**Maricopa County  
Department of Transportation  
Engineering Division**

INITIAL DRAINAGE REPORT

83rd Avenue from  
Northern Avenue to Olive Avenue

January 31, 2000

Figure 2

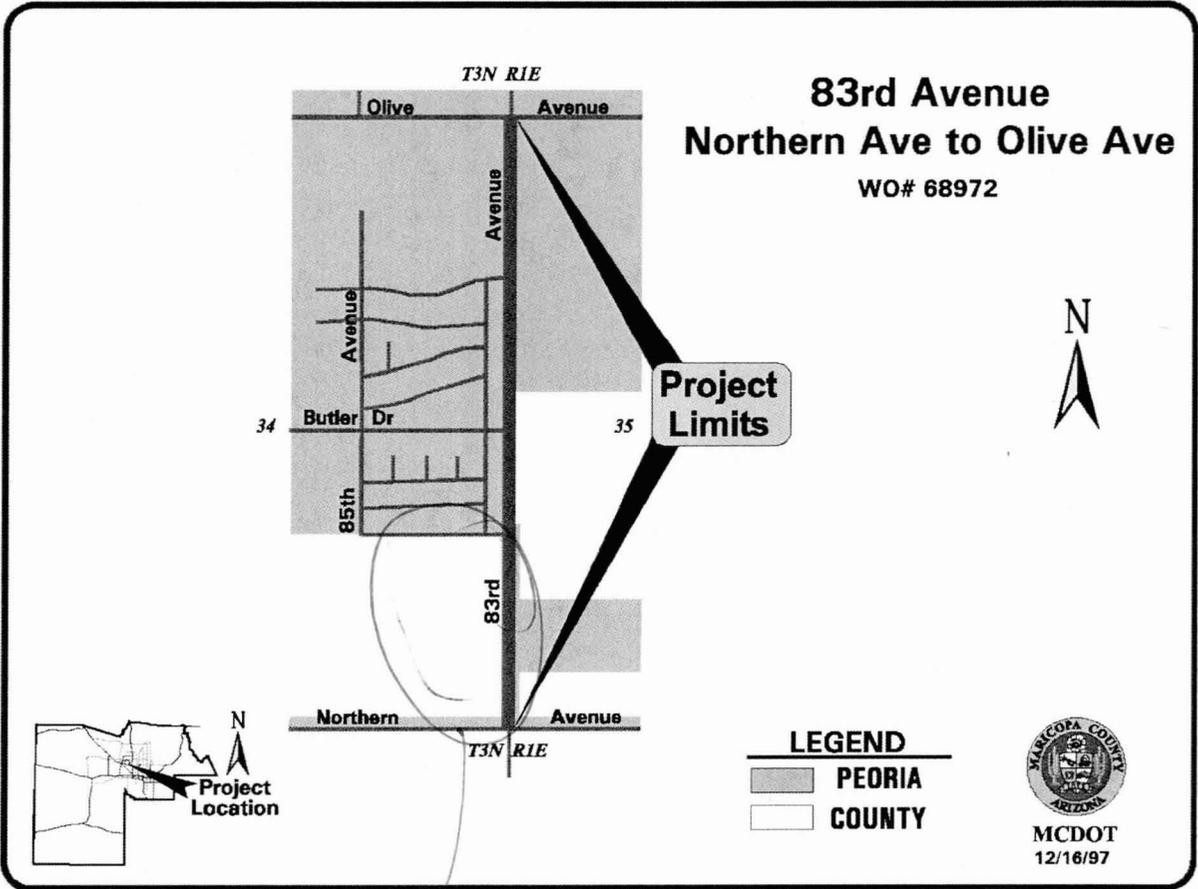
*Show Cas Palmarites Drive*

**APPENDIX A**

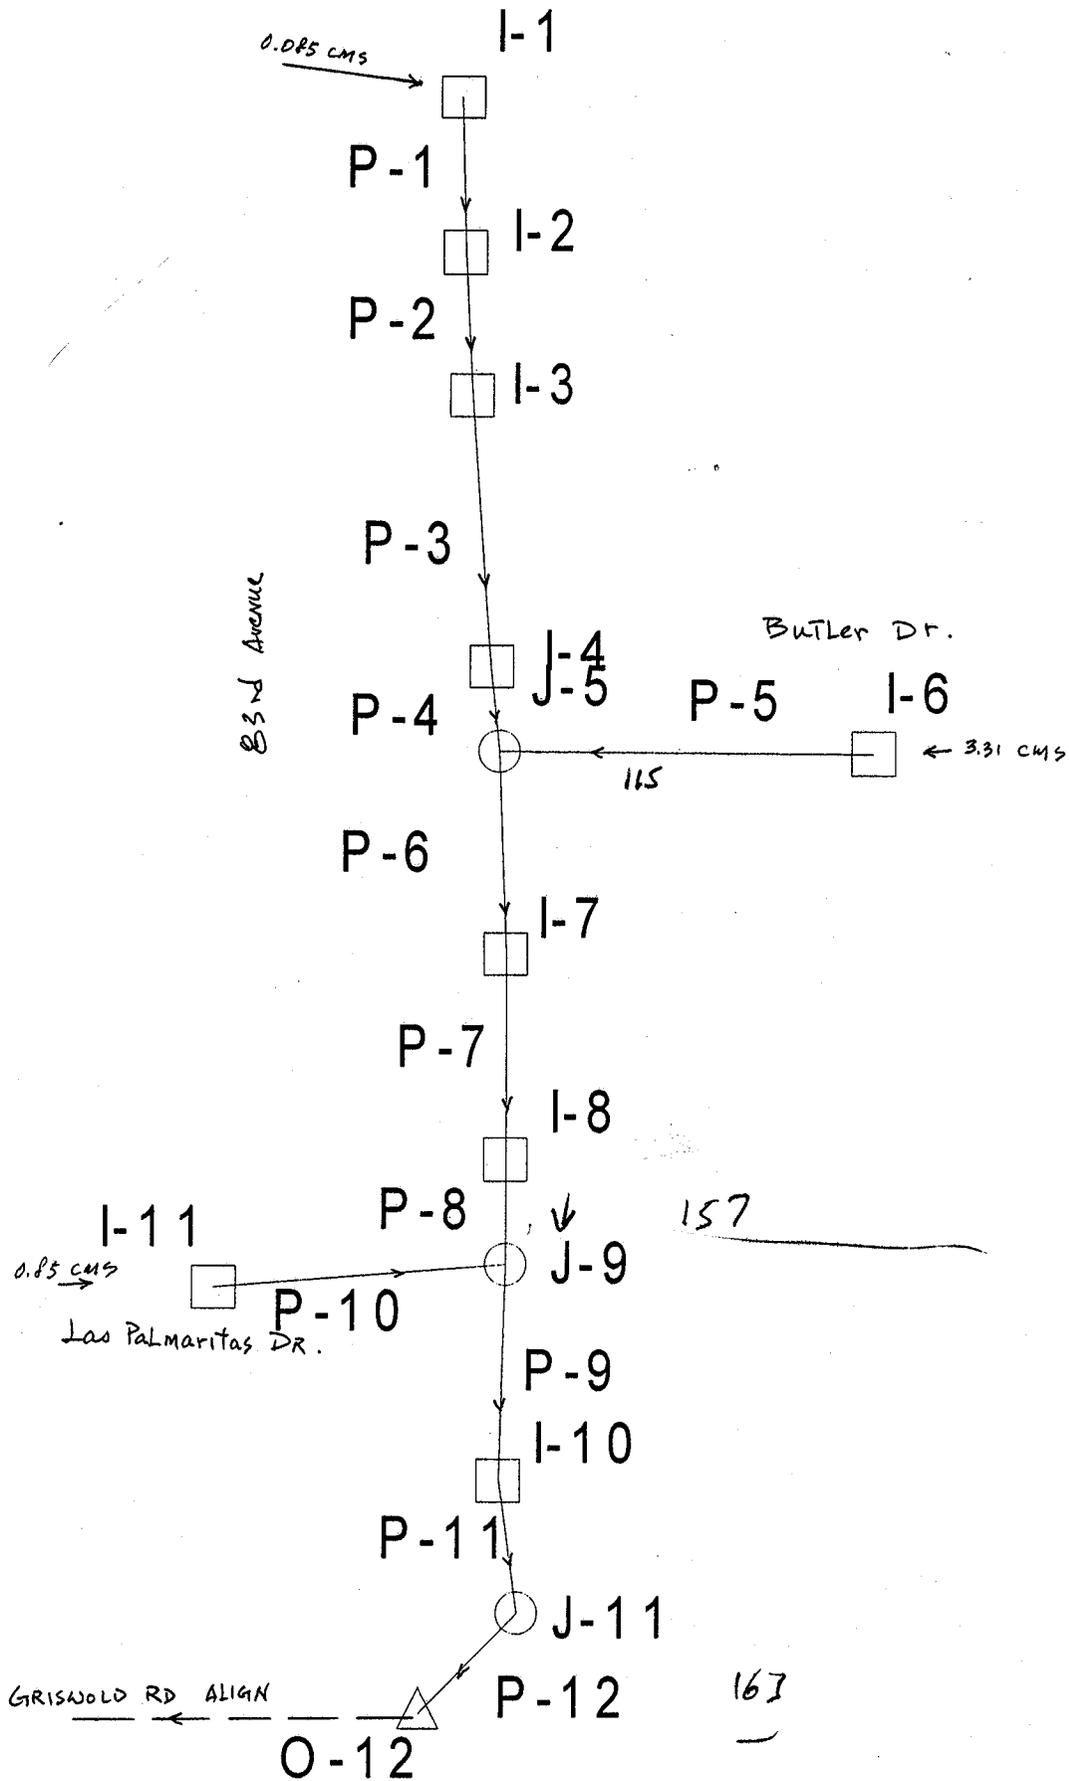
Junction loss greatly underestimated use absolute use H from exper. 2.2 m per sheet D6

Why a drop in flow between P7 & P8?

769 mm for 30" pipe

not forming a pipe

88 m per sheet D6

Should have column showing discharge

1692 for 66"

1384 mm for 54" pipe

30" = 769 mm

not same elev. as shown on sheet D4

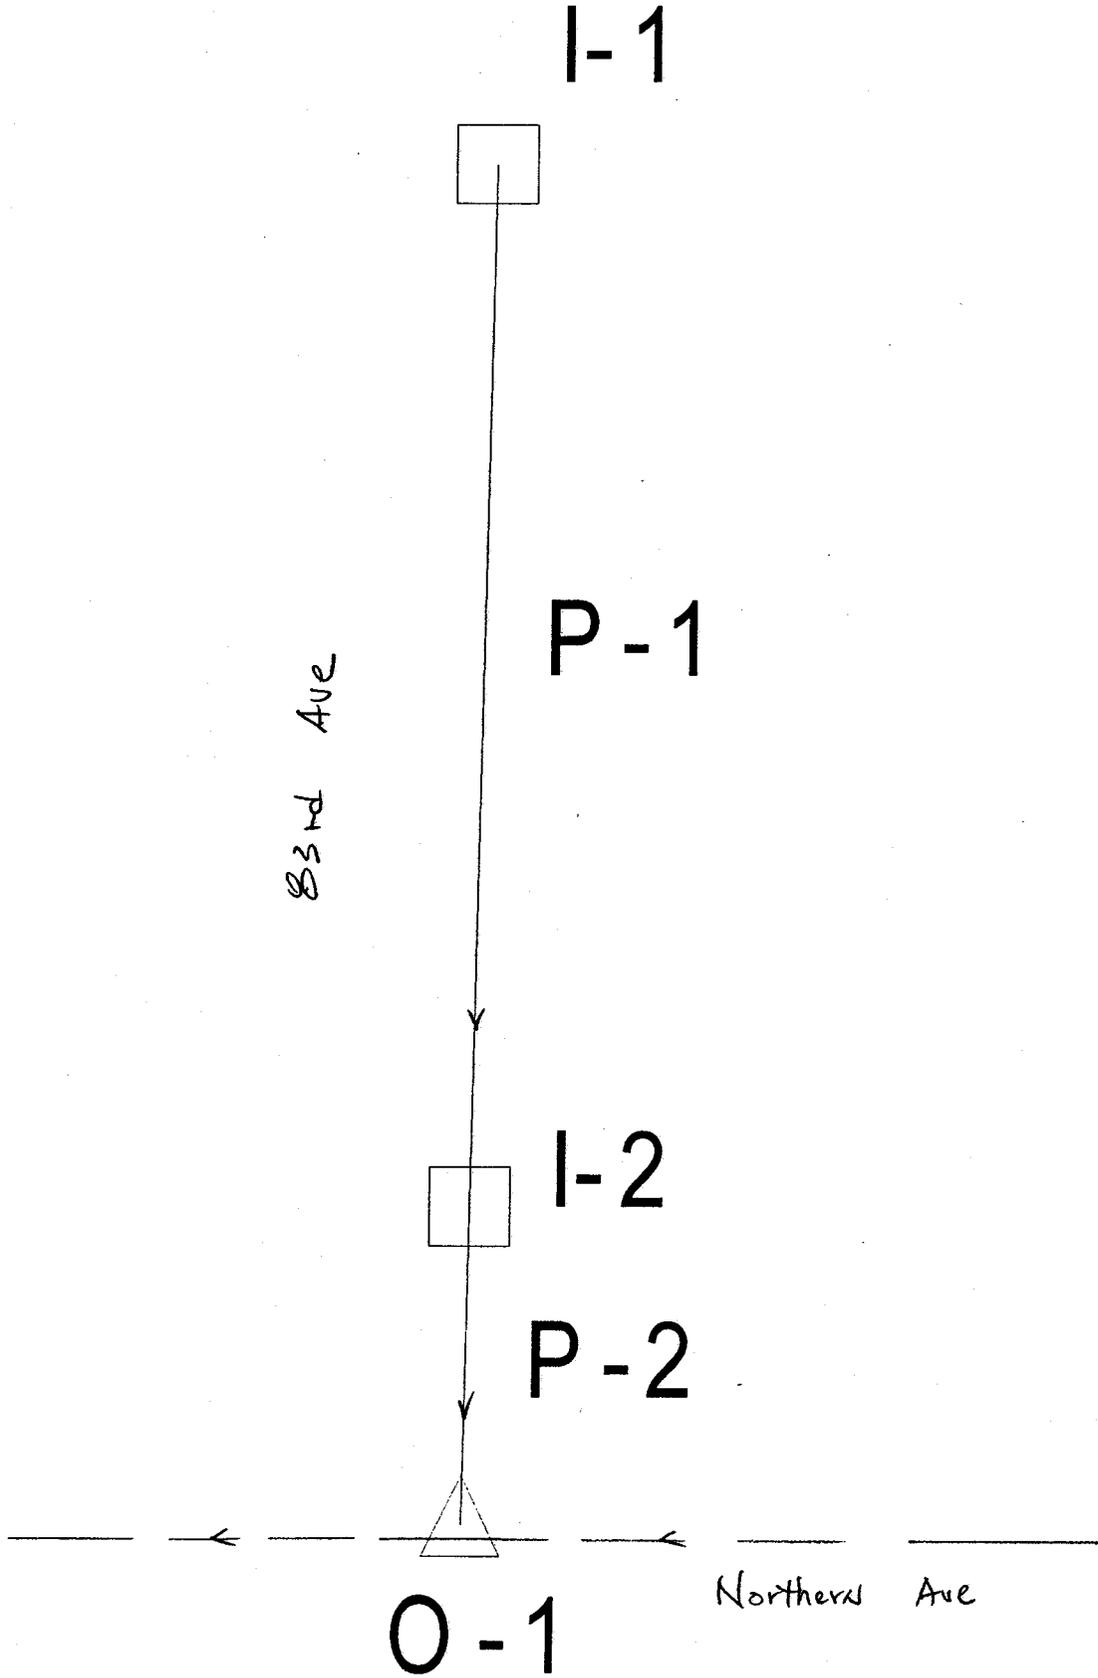
drop of flow

substantiate sump elev. =  $\phi$  for JS

Why is sump elev. =  $\phi$  at O-12

Electronic file shows  $\phi$  inflow at Las Palmantias. Please provide calculations to substantiate modeled junction headloss inputs. Model schematic shows bend at lowermost segment of pipe, but invert elevations don't match Wood, Patel & Assoc. plans

Output should show existing ground elevation; check this elevation for "upstream at node I"

Please substantiate why there is "0" headloss at node I2 although the flow doubles, there

- Model Revisions
- ① Check Inlet Q's (revise Rat calc sheets)
  - ② Add  $h_f$  at I2
  - ③ Add  $h_{MN}$  between I1 & I2 (breaks up length of P1)

$$h_f = \frac{8^2}{(32.2)(1.77)} - \frac{4^2}{(32.2)(1.77)} = 0.42'$$

Phase/Subject 83rd Ave - Catch Basins

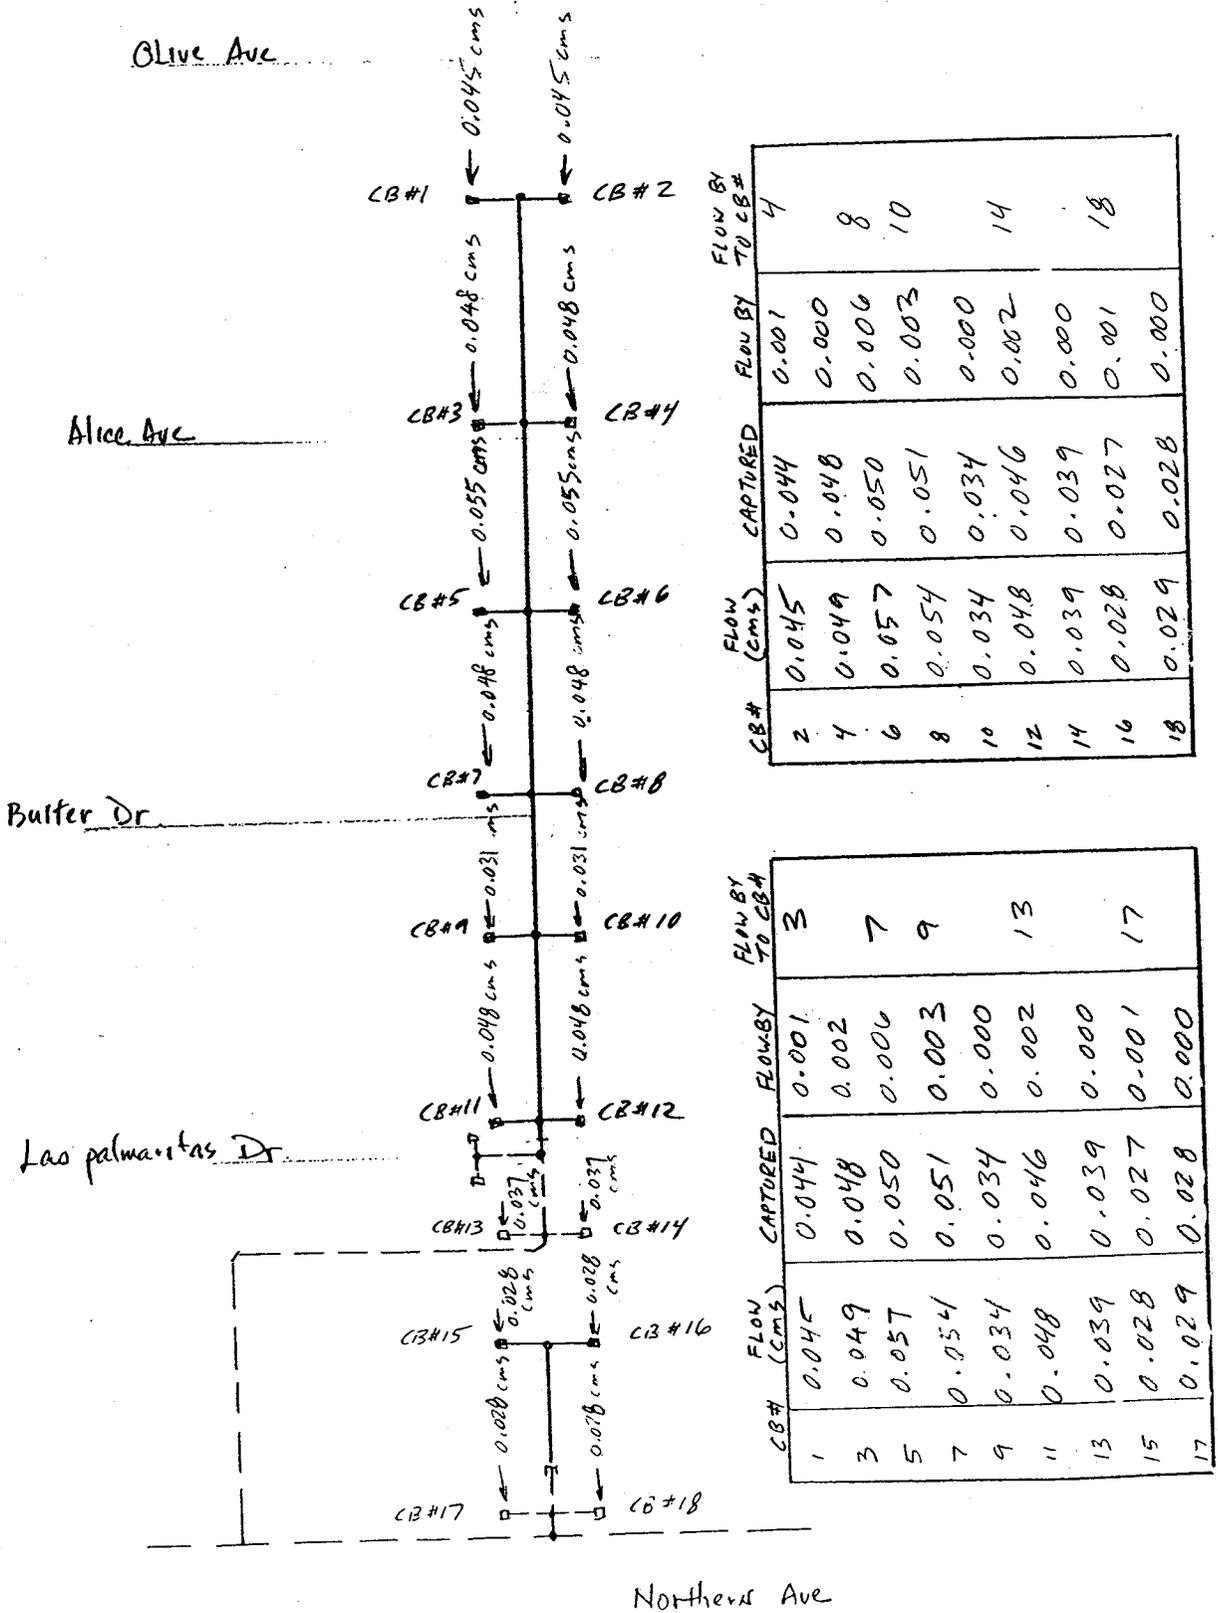
Wireed input

reference eqns.  
provide electronic version of file
